HISTORIC AND DESIGN REVIEW COMMISSION

HDRC CASE NO: 2018-333
ADDRESS: 131 ADAMS ST
LEGAL DESCRIPTION: NCB 931 BLK 1 LOT 15
ZONING: RM-4, H
CITY COUNCIL DIST.: 1
DISTRICT: King William Historic District
APPLICANT: Beverly Bunn/Beaver Meadows II, LLC
OWNER: Beverly Bunn, Beverly Bunn/Beaver Meadows II, LLC
TYPE OF WORK: Installation of a mansard roof over an existing porch roof
APPLICATION RECEIVED: June 25, 2018
60-DAY REVIEW: August 24, 2018
REQUEST:

The applicant is requesting a Certificate of Appropriateness for approval to remove the existing, front porch balcony railing and install a mansard roof featuring a black standing seam metal roof.

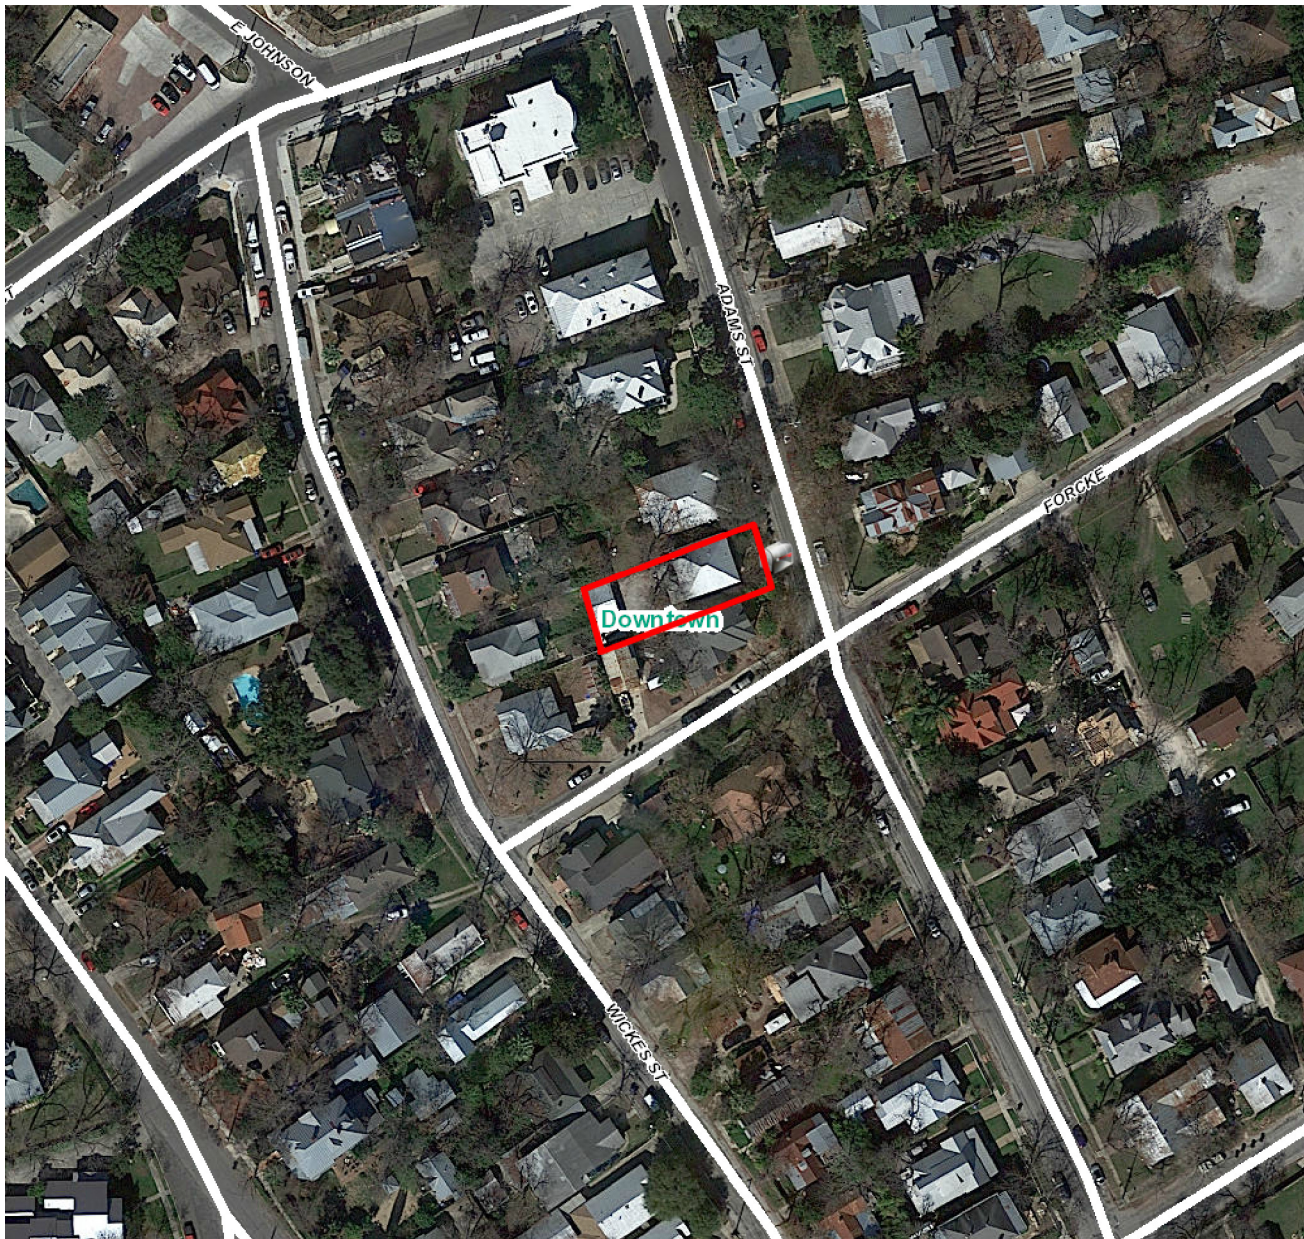
- b. **PORCH MODIFICATION** – The applicant has proposed to remove the existing balusters above the existing porch roof and install a mansard roof to feature a black standing seam metal roof. The Guidelines for Exterior Maintenance and Alterations 7.B.iv. notes that new elements and details should not be added that create a false historic appearance. While the existing porch roof and balusters are not original, mansard roofs are not found commonly throughout the King William Historic District and the proposed installation on the historic structure's existing porch roof is not consistent with the Guidelines. A modification that would create a simple, low pitch

shed roof above the existing roof to accommodate appropriate water displacement would be appropriate.

1951 SANBORN MAP NOTING MODIFIED PORCH DESIGN (CURRENT)

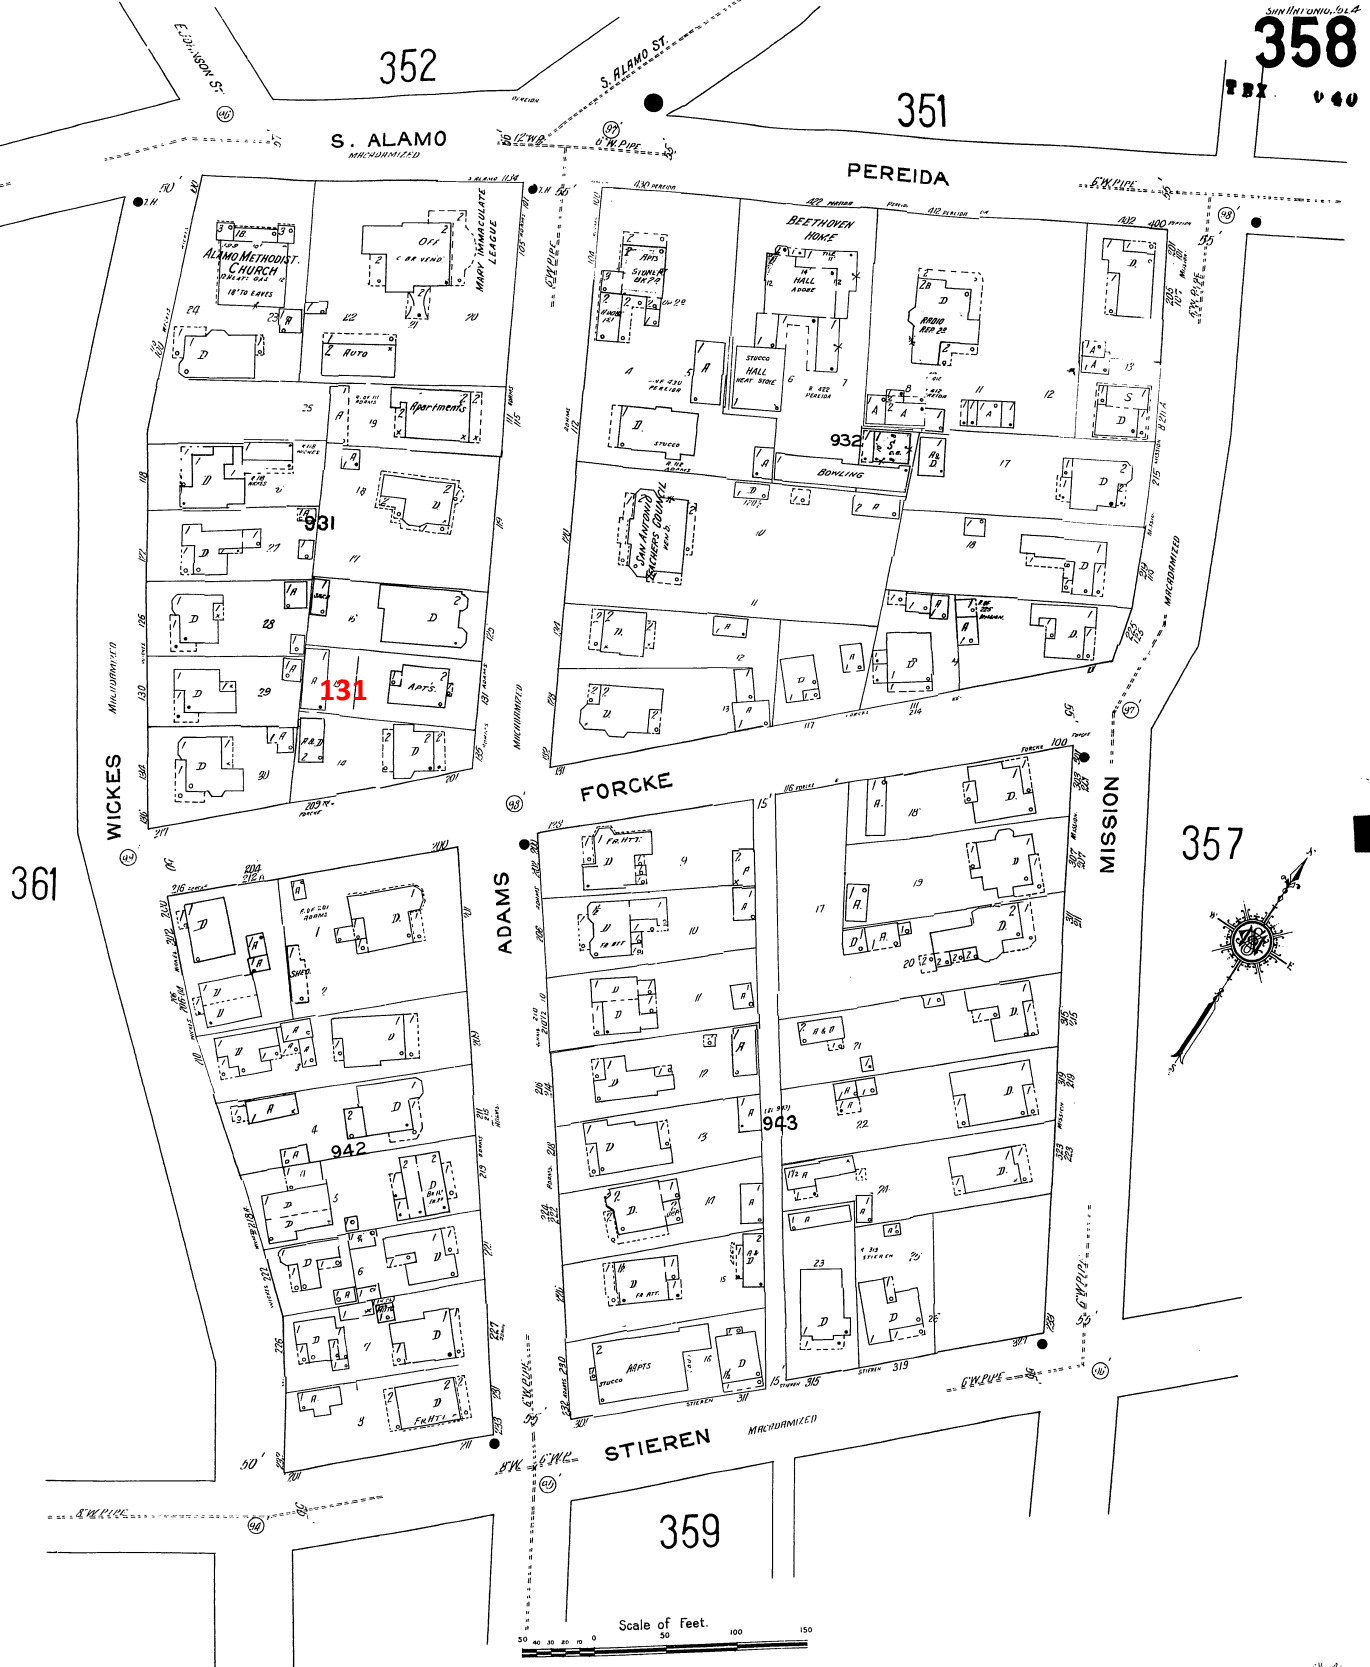
- a. The historic structure at 131 Adams was constructed circa 1910 and is found on the 1912 Sanborn Map. The structure originally featured a double height, wrap around front porch. The original design has been modified to its current state which includes a uniform front facade with a centered, entrance porch with balusters above the porch roof. These modifications which exist presently are found on the 1951 Sanborn Map.

Front elevation
 SCALE: 3/16" = 1'-0"

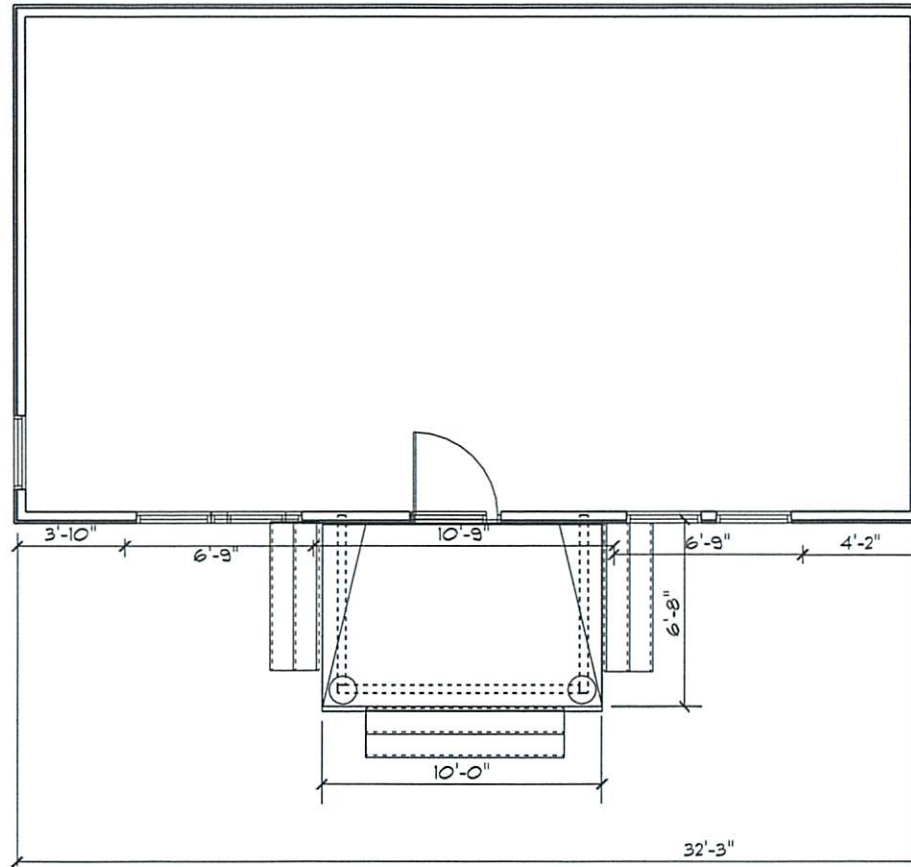
- c. **ROOFING MATERIAL** – The applicant has proposed to install a black, standing seam metal roof. The Guidelines for Exterior Maintenance and Alterations, Checklist for Metal Roofs notes that a standard galvalume finish, or gray color should be used unless historic evidence of an alternate roofing color exists. Staff finds the proposed roofing color to be inconsistent with the Guidelines.
